Commonwealth Edison

October 3, 1984

SUBJECT: Byron Generating Station Units 1 and 2, Technical
Specifications, NRC Docket Nos. ~~50~~-454 and 50-455

The continuing review of the Byron Station Technical Specifications has identified additional changes as noted on the enclosed attachments. It is requested that these changes be incorporated into the final draft of the Technical Specifications dated August 27, 1984, from B.J. Youngblood to D. Farrer.

Figure 6.2-2
 UNIT ORGANIZATION

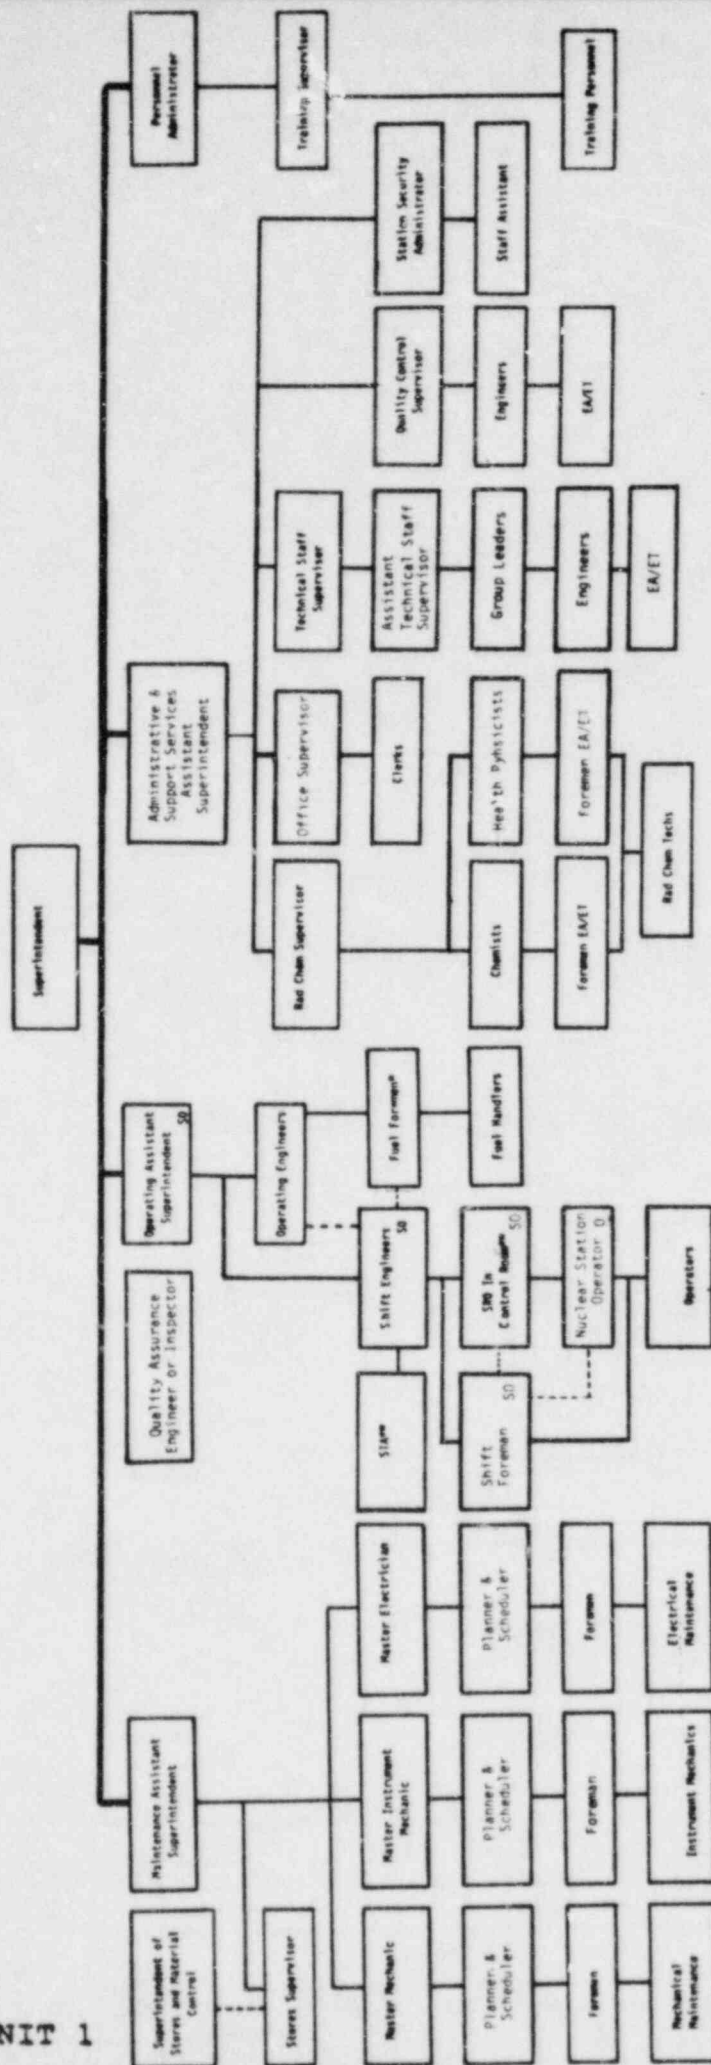
Byron Station proposes to modify Technical Specification Figure 6.2-2, UNIT ORGANIZATION (pg 6-4), as attached.

This revision to Figure 6.2-2 is to resolve a Byron Station senior resident NRC inspector open item 454/84-42-01; 455/84-29-01. This figure is representative of the unit organization.
